SUBJECT: MEETING NOTIFICATION AND TRANSMITTAL OF AGENDA

MEETING MINUTES FROM THE  
MARICOPA ASSOCIATION OF GOVERNMENTS  
STANDARD SPECIFICATIONS AND DETAILS COMMITTEE

## 2010 PROPOSED REVISIONS TO MAG SPECIFICATIONS AND DETAILS

CURB RAMP - TYPE 'C'  
OPTION A

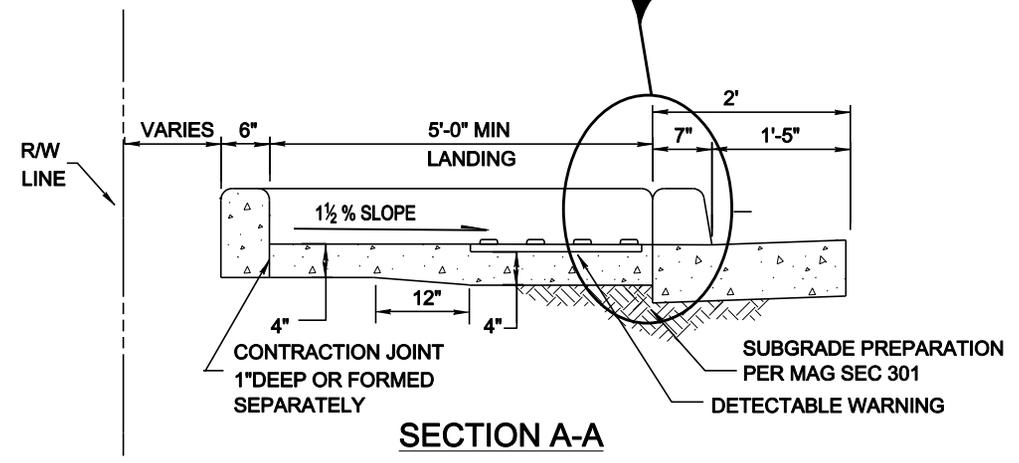
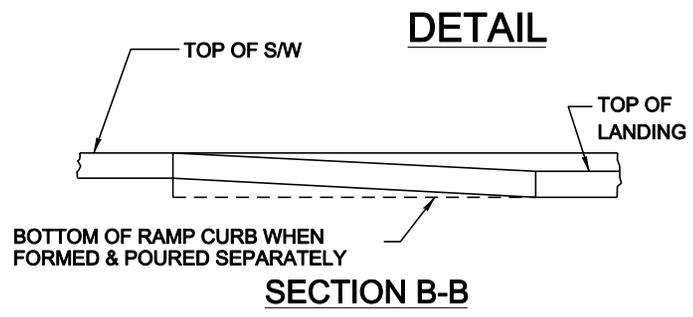
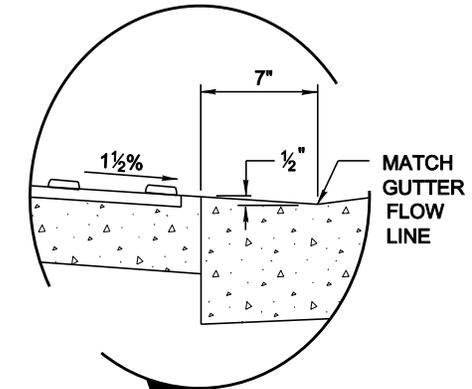
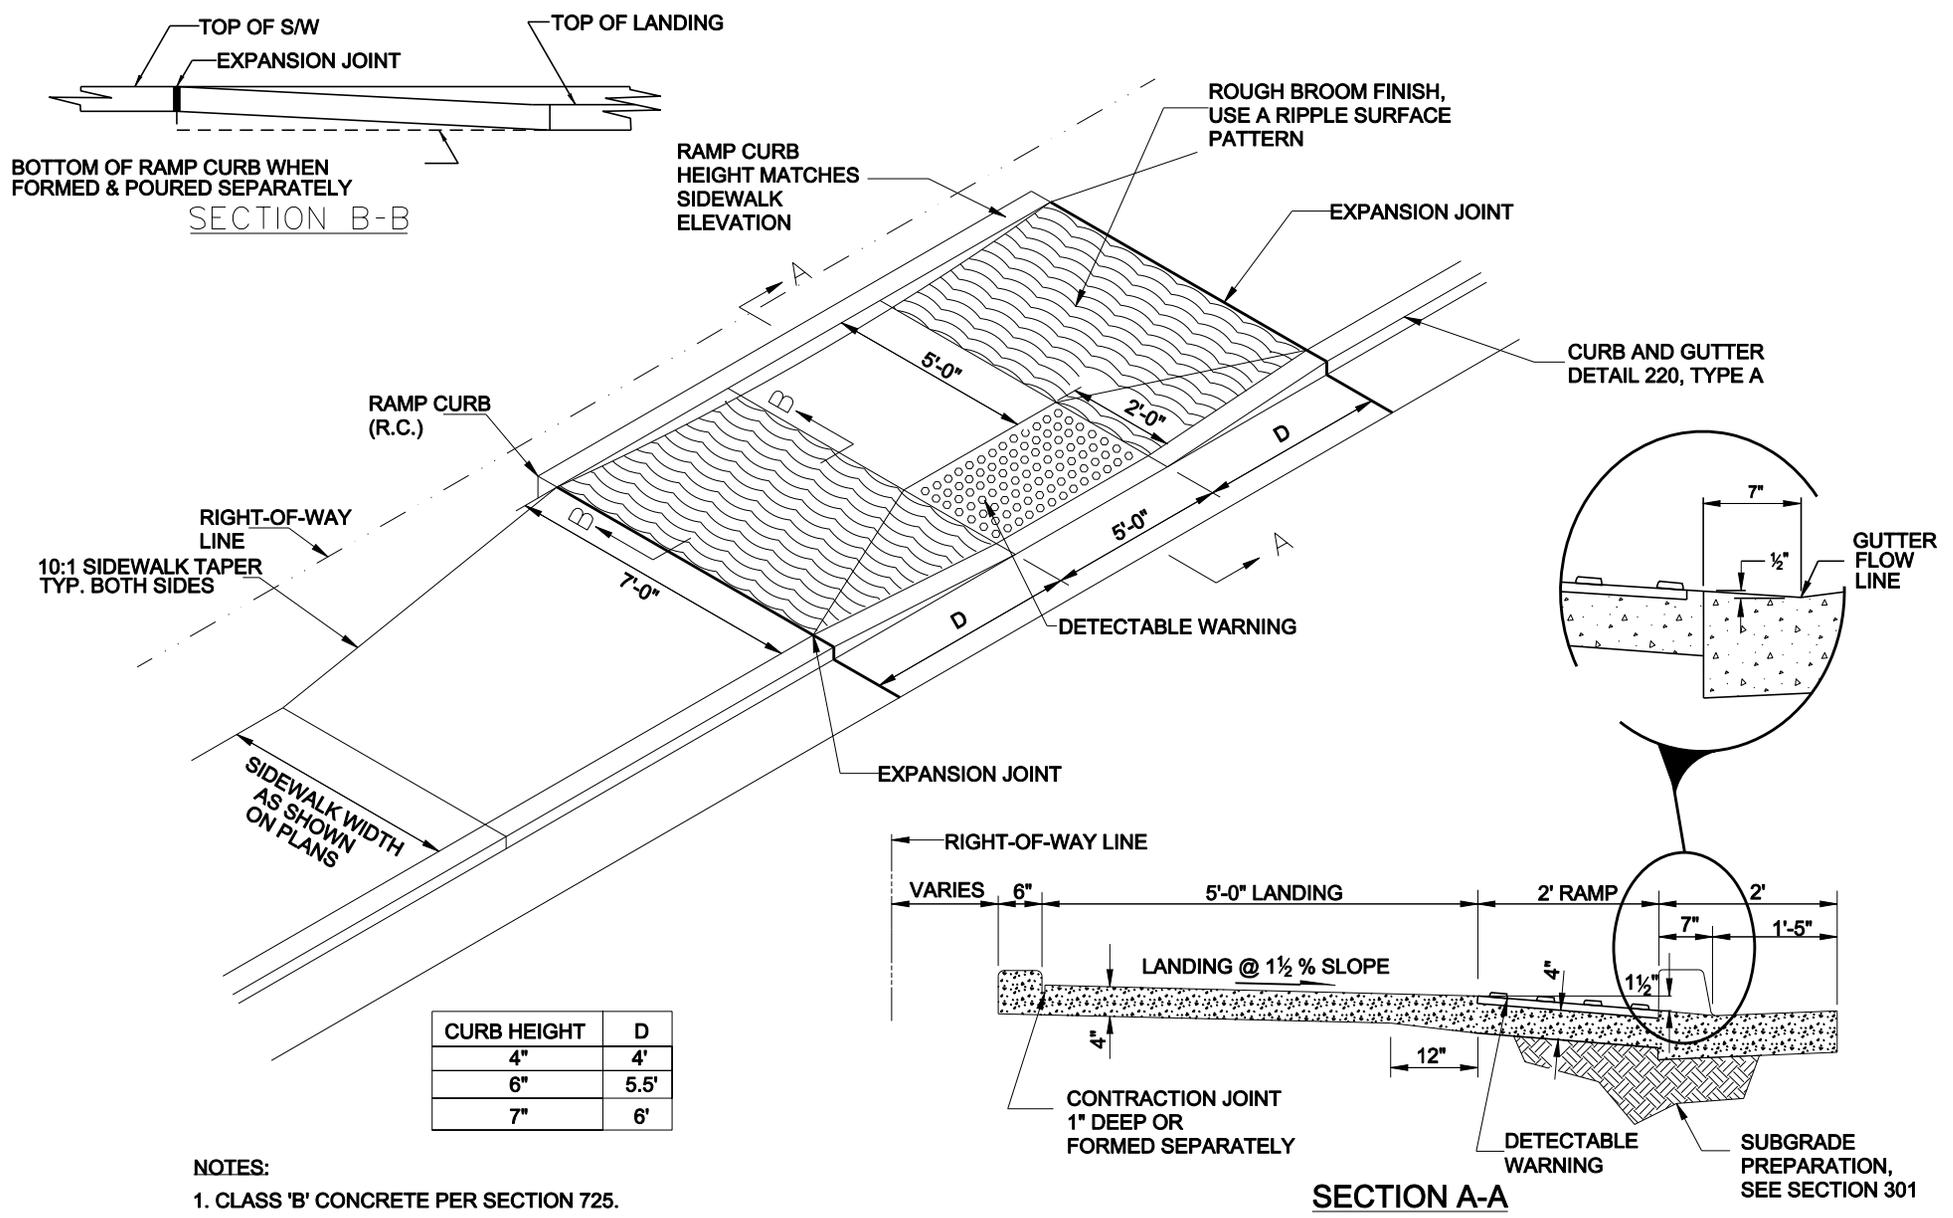
**b. Case 09-14 – Revise Ramps for ADA Compliance:** *Revise Details 231, 232, 233 and 234 to obtain compliance with ADA requirements.* Bob Herz provided two new details for Curb Ramp – Type ‘C’ to replace the current MAG Detail 233. The new details modify ramps to include a 5’ landing. *Option A* shows ramps for sidewalks adjacent to curbs, and *option B* illustrates ramps for sidewalks set back from the curb. The width of the ramps would vary depending on the curb height. Rod Ramos noted that the ramps could have a slope greater than 12-1 for some installations if you only go by the table that determines dimension ‘D’. He promoted the use of an elevation worksheet as is done in Scottsdale, or the use delta elevations to determine an allowable range for the use of the detail. Jesse Gonzales suggested that a note could be added to clarify slope requirements. Members agreed that the slopes need to be checked, and the detail may need to be modified depending on site conditions. Mr. Herz asked for additional feedback from the committee on these details as well as the previously submitted Detail 232.

CASE 09-14 REV 4/29/2010

1. CLASS 'B' CONCRETE CONSTRUCTION PER SECTION 725.
2. DETECTABLE WARNING IS TO COMPLY WITH THE JURISDICTIONAL AGENCY'S REQUIREMENT.
3. RAMP LONGITUDINAL SLOPE SHALL BE 12:1 OR FLATTER.
4. RAMP CROSS SLOPE SHALL BE 1½%.

Subject: Proposed revision to Standard Detail 230 - SIDEWALKS Case 10-07

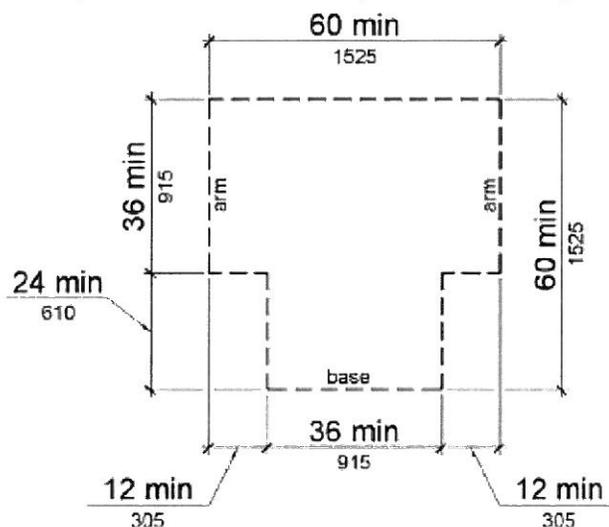
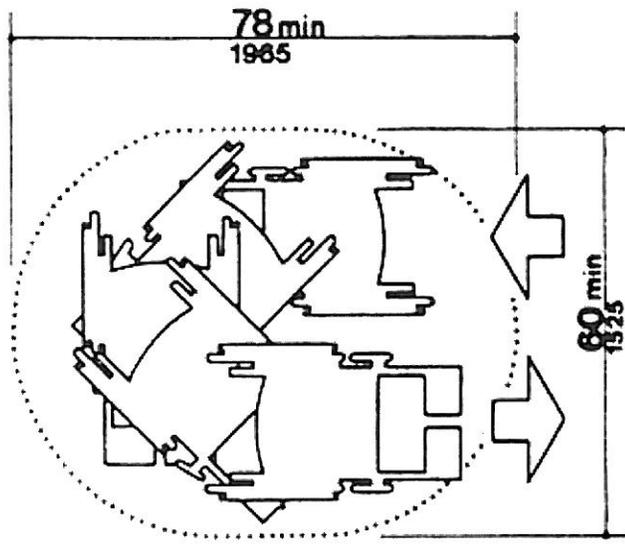
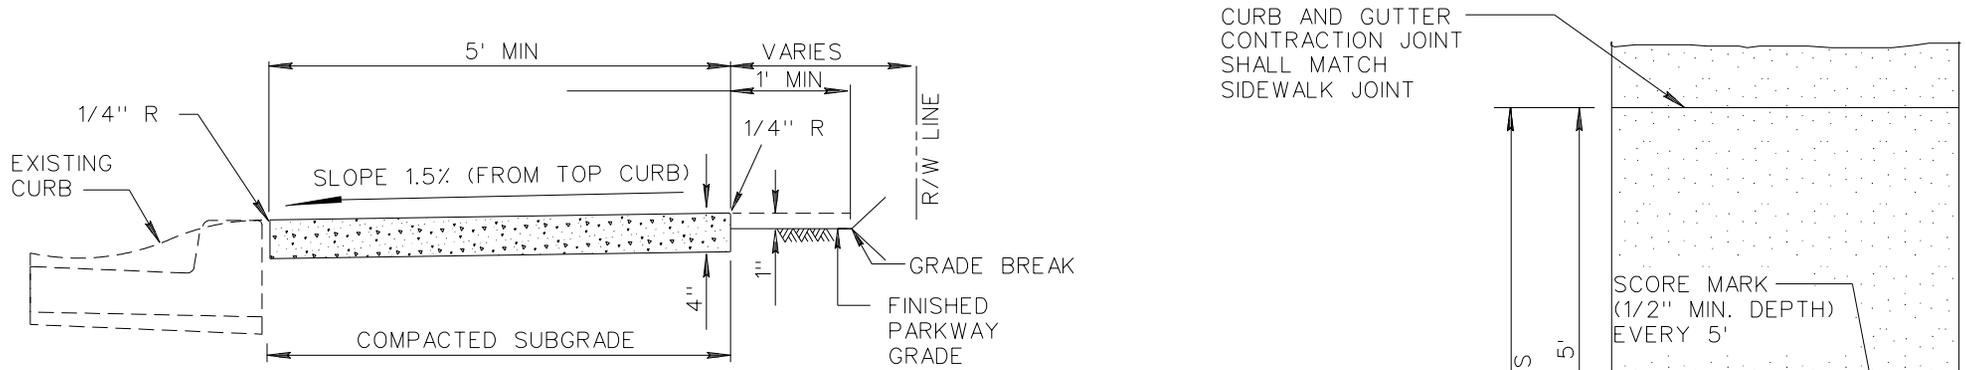
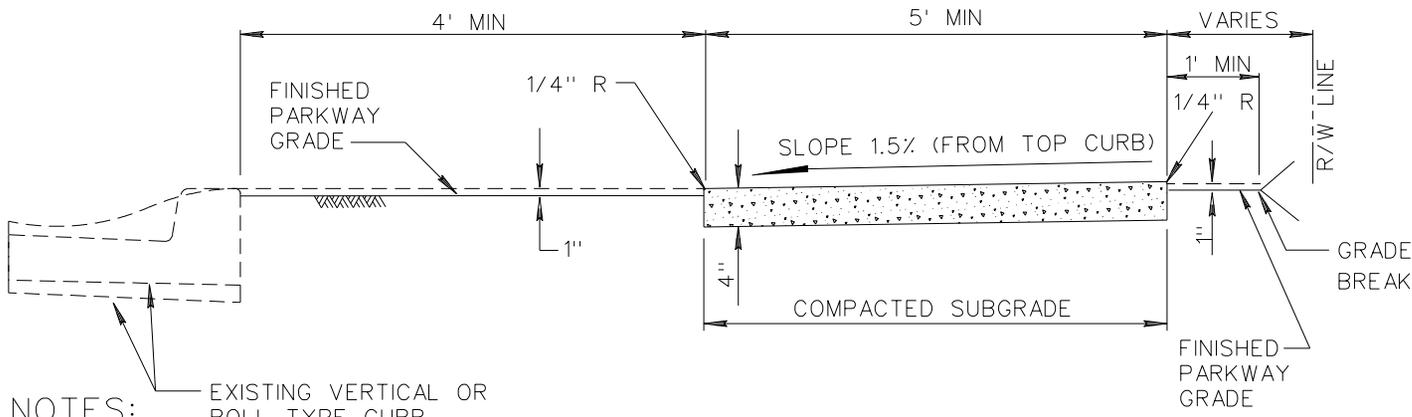
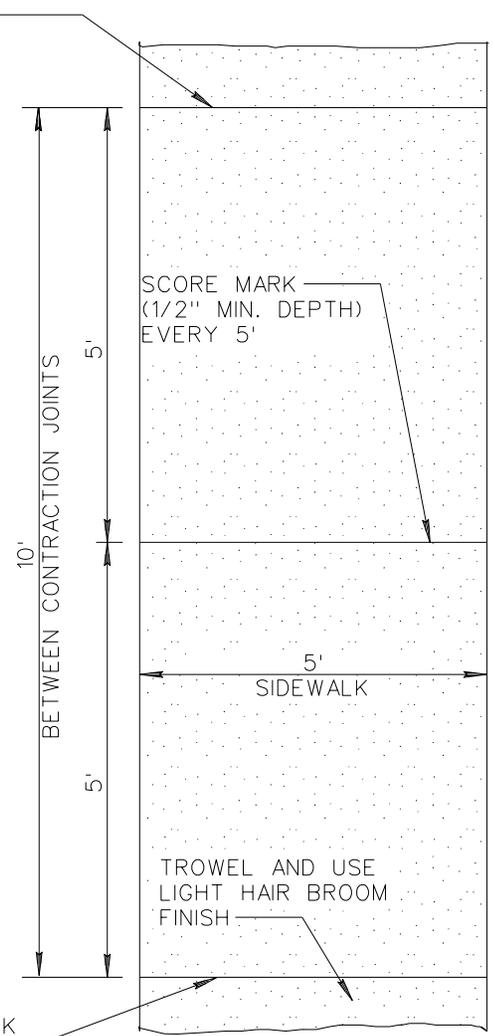
**j. Case 10-07 – Revise Detail 230 – Sidewalks to change minimum from 4' to 5':** *Revise the minimum sidewalk width to match the minimum ADA requirements for two wheel chairs to pass, and to allow a wheel chair to u-turn.* Bob Herz provided an updated detail that showed the grade break at the back of the sidewalk since it is included in Maricopa County's detail. One comment noted the grade break would not be needed for areas with zero setbacks from the sidewalk. Rod Ramos said Scottsdale has a supplement that uses a thicker concrete sidewalk that can support the weight of emergency vehicles that may drive over them. John Ashley asked if the 1" drop from the sidewalk to the planter area could cause a tripping hazard. Mr. Herz said it is not designed for pedestrians to walk in that area and other supplemental details also have the 1" elevation difference.

PURPOSE: Revise minimum sidewalk width to match the minimum ADA requirements for two (2) wheel chairs to pass and to match minimum ADA requirements for a wheel chair to u-turn.

REVISION: Revise minimum sidewalk width from 4' to 5'.

**Subject:** Proposed revision to Detail 145 – SAFETY RAIL

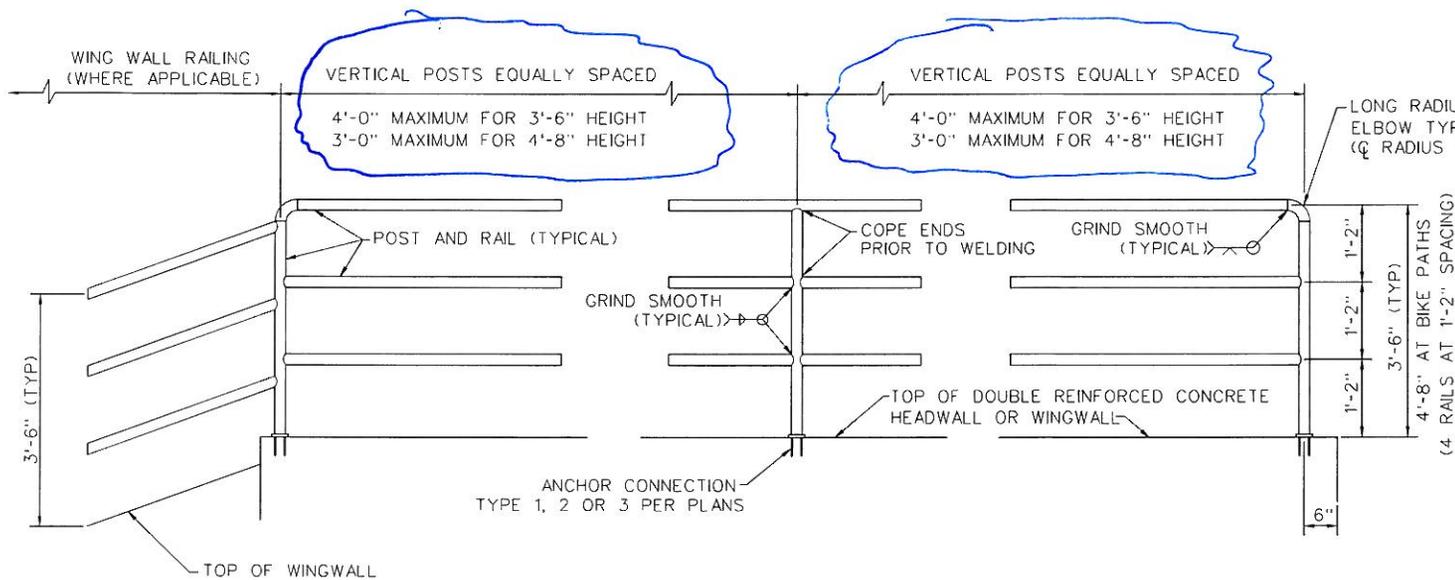
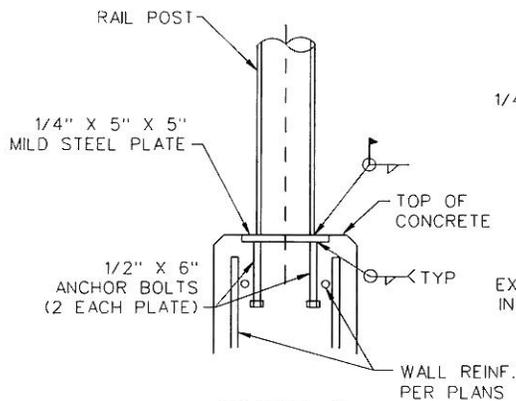
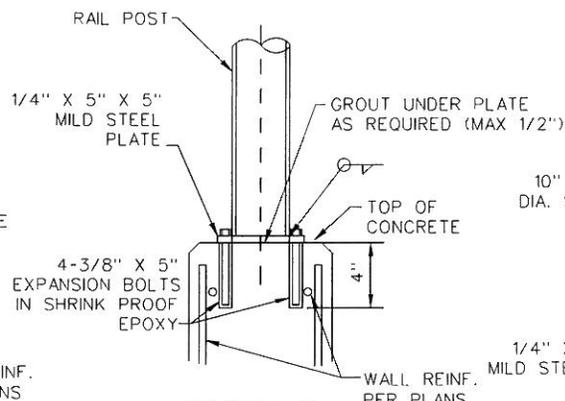
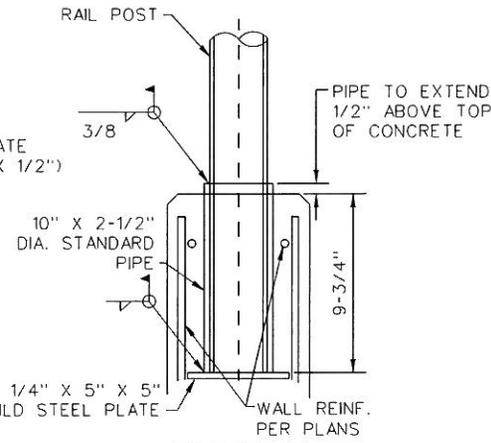
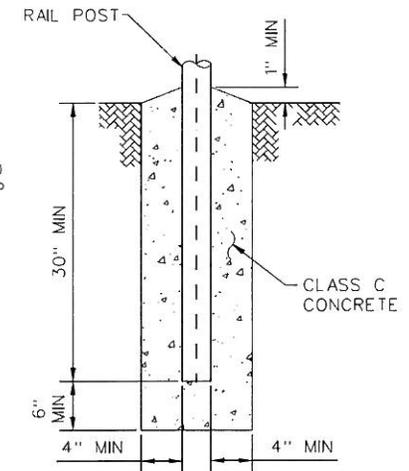
**l. Case 10-09 – Revise Safety Rail Detail 145.** *Adjust Detail 145 to comply with AASHTO pedestrian loading requirements.* Bob Herz submitted a new case that updates MAG's safety rail detail to meet the AASHTO loading requirements of 50 plf applied at the top of the rail. This is done by decreasing the distance between posts and specifying a higher grade B steel post. Committee members asked if it was necessary to change the spacing if the rail is used as intended. Mr. Herz said on a project in Maricopa County the railing was used along a bridge and had to meet AASHTO standards. He said the revisions would also meet building code standards. Jami Erickson asked if the railing shown on the scupper detail should also be updated.

**PURPOSE:** Adjust detail to comply with AASHTO pedestrian loading requirements.

**DISCUSSION:** AASHTO pedestrian bridge rail loading is 50 plf applied to the top of rail. Keeping the 8'-0" maximum post spacing would required the post diameter to be increased to a 2" diameter schedule 80 pipe for a 3'-6" high rail and require a 2½" diameter schedule 40 pipe for a 4'-8" high rail.

**REVISION:** Revise in note 1 the grade of ASTM A53 steel pipe from grade A ( $F_y = 30\text{ksi}$ ) to grade B ( $F_y = 35\text{ksi}$ ). Revise post spacing from 8'-0" maximum to 4'-0" maximum for 3'-6" rail and to 3'-0" maximum for the 4'-8" rail.

1. POSTS AND RAILS SHALL BE 1.5" SCHEDULE 40 HOT-DIPPED GALVANIZED STEEL PIPE ASTM A 53, **GRADE B** (2.72 ±.1/F, 1.9" O.D.). GALVANIZING SHALL BE IN ACCORDANCE WITH SECTION 771.
2. PAINT RAIL PER MAG SPECIFICATIONS SECTION 530 WHEN REQUIRED BY PLANS. SHOP PRIME WITH RUST INHIBITING PRIMER (FIELD REPAIR PRIMER AS NEEDED). COLOR PER PLANS.
3. VERTICAL POSTS TO BE EVENLY SPACED.
4. REMOVE ALL SHARP EDGES.
5. INSTALL SAFETY RAIL AS REQUIRED BY PLANS OR SPECIFICATIONS.
6. THE EMBEDMENT FOR ANCHOR TYPES 1, 2 AND 3 SHALL BE LOCATED INSIDE THE WALL REINFORCEMENT CAGE.

**Subject:** Proposed New Detail 122 – PAVEMENT MARKER FOR FIRE HYDRANTS **Case 10-10**

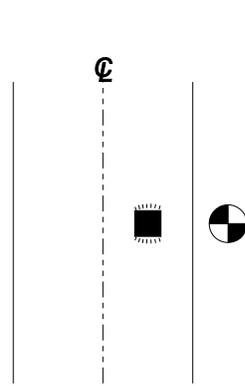
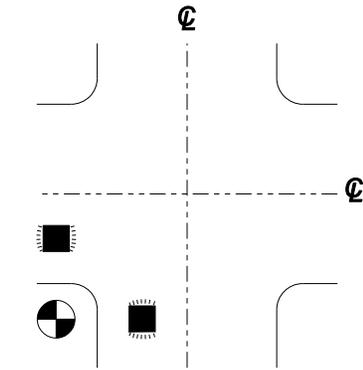
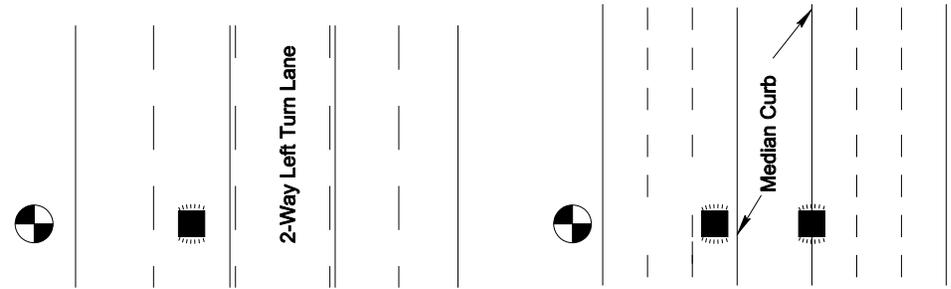
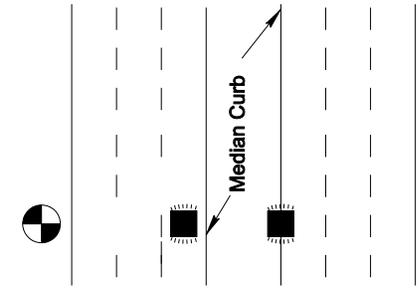
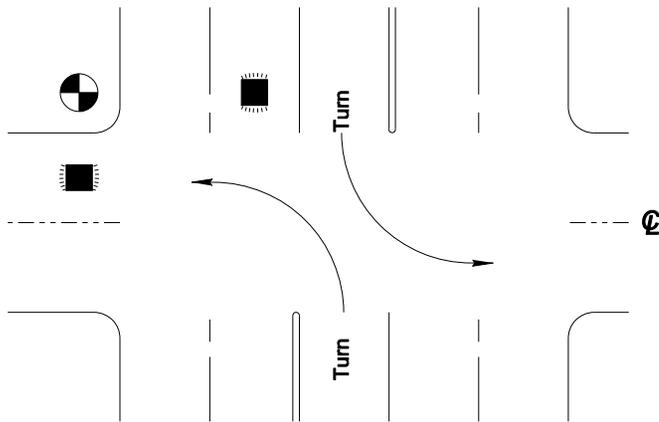
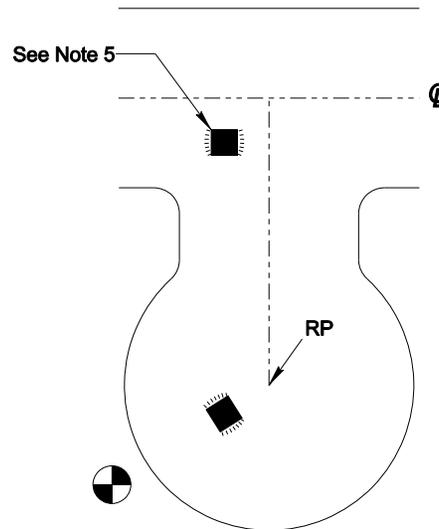
**m. Case 10-10 – Proposed New Detail 122 – Pavement Marker for Fire Hydrants.** *The new detail would standardize placement of fire hydrant markers and enhance public safety.* Bob Herz submitted a new Detail 122 that identified standard locations of fire hydrant pavement markers for local streets (including those with left turn lanes and medians), cul-de-sacs, and types of intersections. He asked for members to take the detail back to their agencies and fire departments to see if they will work as shown.

**PURPOSE:** Standardize placement of fire hydrant markers. Enhance public safety.
